Our reference: 511270

RFI Response – Private Plan Change 18

Reference: Cashmere Fields Plan Change- RFI Transport Responses

Figure 1: ODP Western Cashmere Road Intersection Location

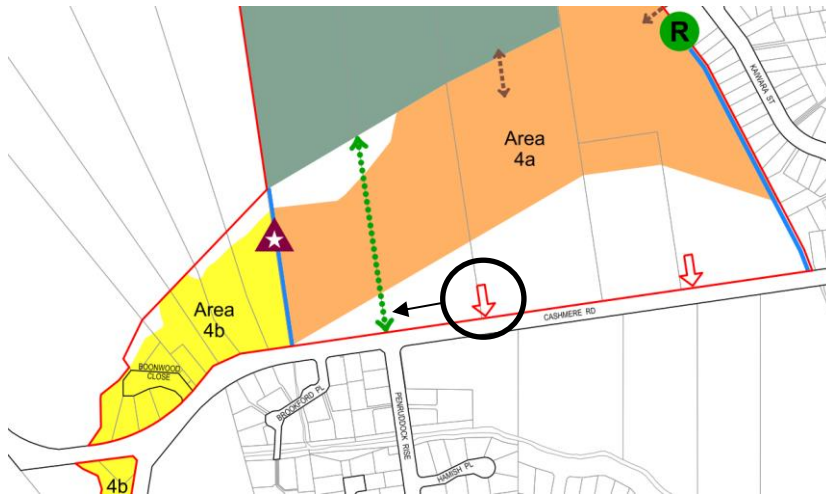
Request 3: Please provide additional modelling scenario in CAST for the vehicle access onto Cashmere Road to be connected at Penruddock Rise intersection through the proposed roundabout, as this may highlight further adverse increases in vehicle movements on existing and proposed residential roads.

Response 3: We understand that this request relates to the location of the western Cashmere Road intersection within the ODP area (circled below). As shown, the ODP has this intersection to the east of

Penruddock Road, whereas the request suggests that this road may be constructed opposite Penruddock Rise along with a roundabout on Cashmere Road.

Regardless of the position of this intersection, development of the site will only contribute low traffic volumes to this new local road. The CAST outputs, shown below, suggest the additional development that would be enabled through the proposed Plan Change could contribute approximately 20 – 30 vehicle movements per hour to the new road. This is a low traffic volume which would readily be accommodated on the local road network. The forecast increased use of Cashmere Road as a result of additional development enabled by the Plan Change is modest and would not impact the arterial road network. Accordingly, we are of the view that further CAST modelling with respect to this intersection location is not required and will not be of benefit.

AM Peak Flow Difference Plot- 2038 'With Development' minus 2038 'Without Development'

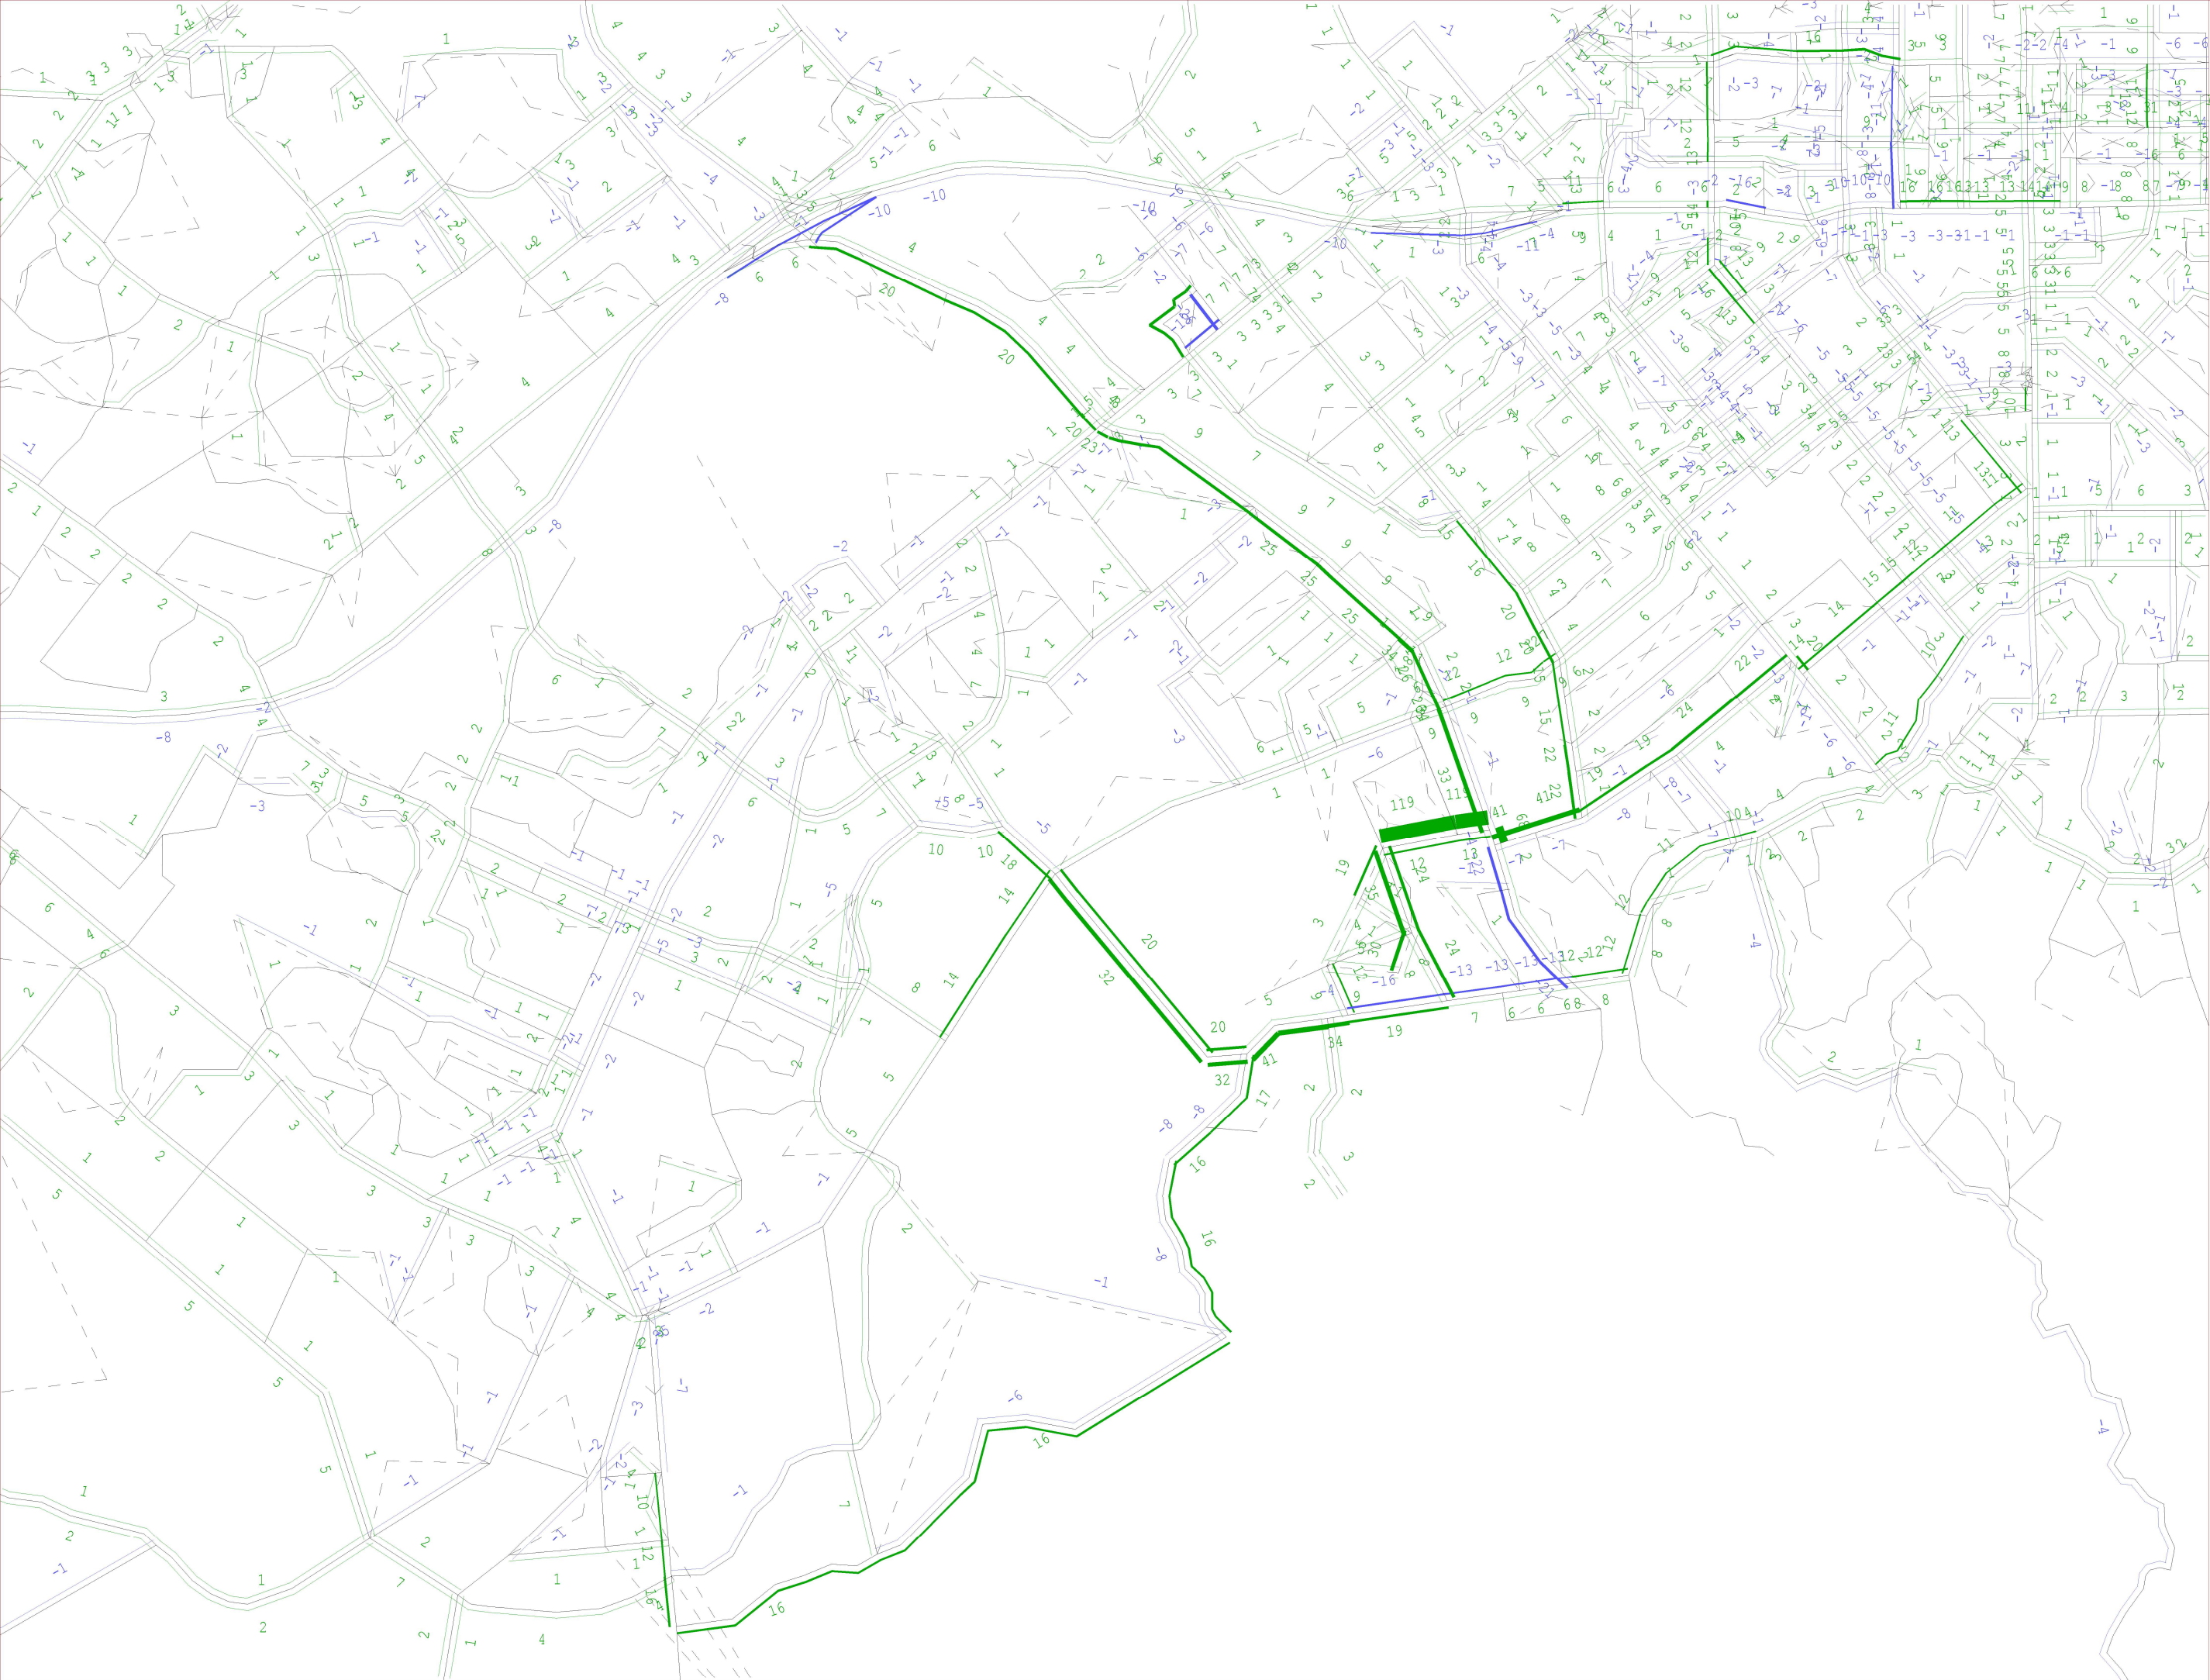
Request 2: Please provide additional CAST model outputs of volume and delay difference plots between the existing and rezoning scenarios.

Response 2: These are provided in Attachment 2.
